**Uniform provisions concerning the approval of motor vehicles with regard to the Advanced Emergency Braking System (AEBS) for M<sub>2</sub>, M<sub>3</sub>, N<sub>2</sub> and N<sub>3</sub> vehicles**

## Industry draft proposals with purple text

**Figure 1:**  
**Left turn or right turn at the intersection**

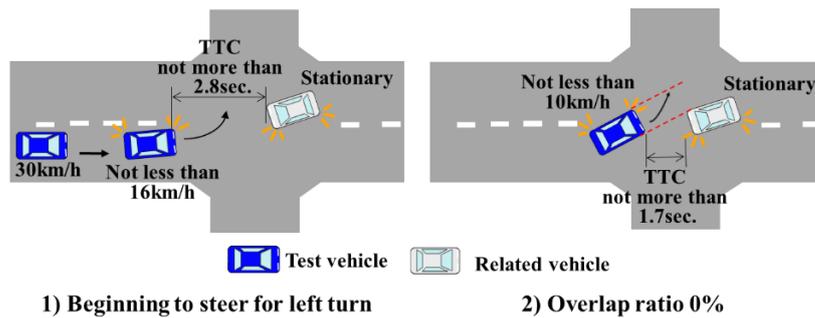
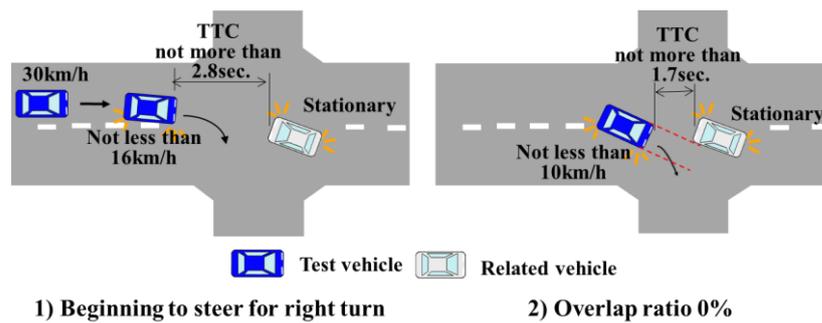
The blue car needs to be changed from passenger vehicle to large vehicle.

**Figure 2:**  
**Right turn or left turn of a forward vehicle**

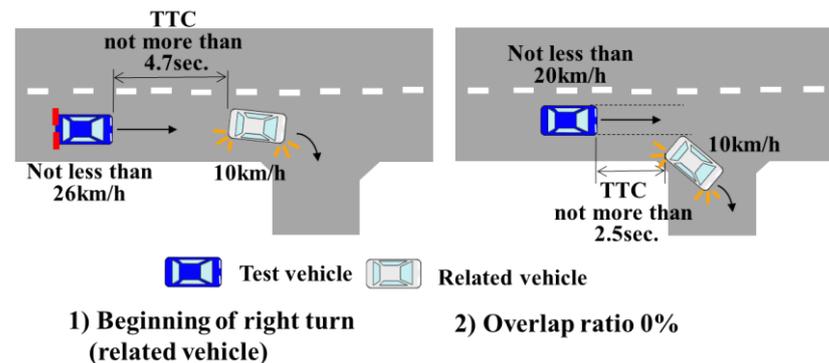
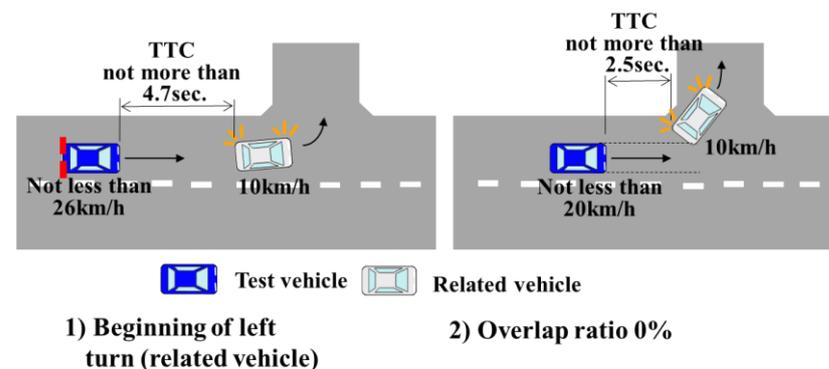
The blue car needs to be changed from passenger vehicle to large vehicle.

**Figure 4:**  
**Lane change due to road construction**

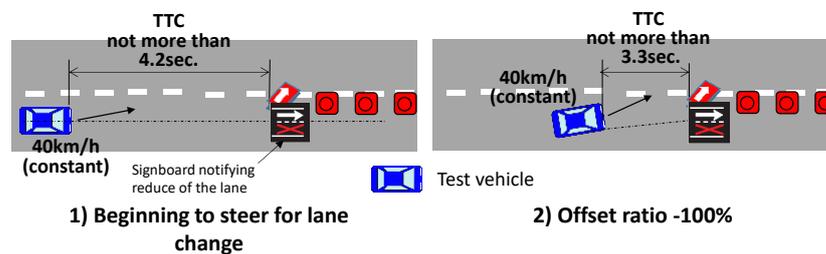
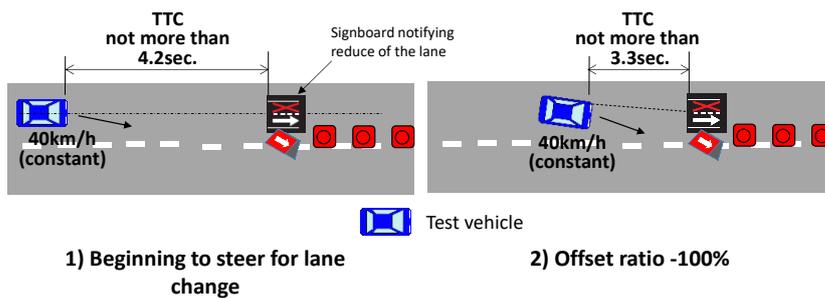
The blue car needs to be changed from passenger vehicle to large vehicle.
